Our Ref: 241745-C1

**RE: ALSPEC STORAGE AND DISTRIBUTION WAREHOUSE – Lot 11
221-227 & 289-317 LUDDENHAM ROAD, ORCHARD HILLS, NSW
CIVIL ENGINEERING - RESPONSE TO SSDA RFI [01]**

Figure 2 – MUSIC Results

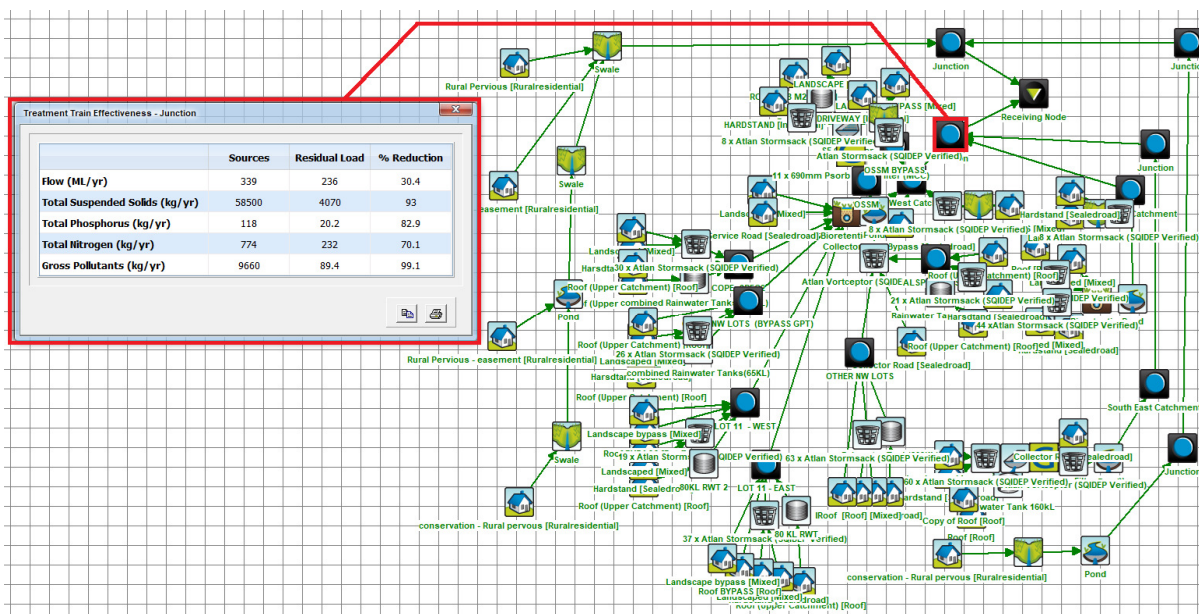
The applicant should provide a MUSIC model for this specific SSD application that includes both the interim and ultimate stormwater strategy for the construction of this warehouse. The applicant must demonstrate how the Alspec Warehouse fits into the business park stormwater strategy, and that waterway health targets will be met.

A MUSIC model for the AIBP estate has been prepared, which incorporates the design for the Alspec Storage and Distribution Warehouse on Lot 11. The results of the MUSIC model have been summarised below. The model is consistent with the approved MUSIC model that was prepared at the DA stage for the AIBP subdivision works.

The MUSC model has been setup as per Figure 1 below. The pit schedule on drawing 241745_DA_C200 Revision 3 has been updated to clarify that pit baskets are required in each inlet pit within the subject site.
